Applic. No. 10/536,581
Amdt. dated June 14, 2007
Reply to Office action of March 14, 2007

Drawing Amendments

Remarks/Arguments:

FIG. 1A

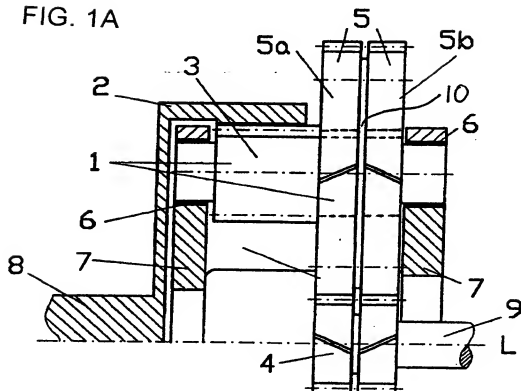
More specifically, the Examiner has stated that devices for axial and/or rotational displacement in claim 12, cup springs of claim 20, toothing profile of the straight-toothed planetary gearwheel with a tip thereof shortened, as a shaft profile for the axial guidance of one or of both half wheels by way of a corresponding inner profile on the shaft of claim 21, adjusting plates of claim 22, and devices to orient said second half wheel with respect to said first half wheel of claim 24, must be shown or cancelled from the claims.

Fig. 1a has been changed to show the feature of claim 21 that the toothing profile of the straight-toothed planetary gearwheel with a tip thereof shortened, as a shaft profile for the axial guidance of one or of both half wheels by way of a corresponding inner profile on the shaft. Accordingly, the objection to the drawing by the Examiner pertaining to claim 21 has been overcome.

Fig. 1a has been amended to include the reference numeral "10", which designates the adjusting plate. Accordingly, the objection to the drawing by the Examiner pertaining to claim 22 has been overcome. The specification has also been amended to reflect the change.

With respect to claim 24, applicants note that Fig. 1 has been amended to designate the plate and the shortened toothing of the straight-toothed gearwheel. Both of these features are

The attached sheet of drawings includes changes to Fig. 1A. This sheet which includes Figs. 1A and 1B, replaces the original sheet including Figs. 1A and 1B. In Fig. 1A, previously omitted reference symbol 10 and hidden lines designating the shortened tip were added.

Please approve the drawing changes that are marked in red on the accompanying "Annotated Sheet Showing Changes" of Figs. 1A and 1B. A formal "Replacement Sheet" of amended Fig. 1A is also enclosed.
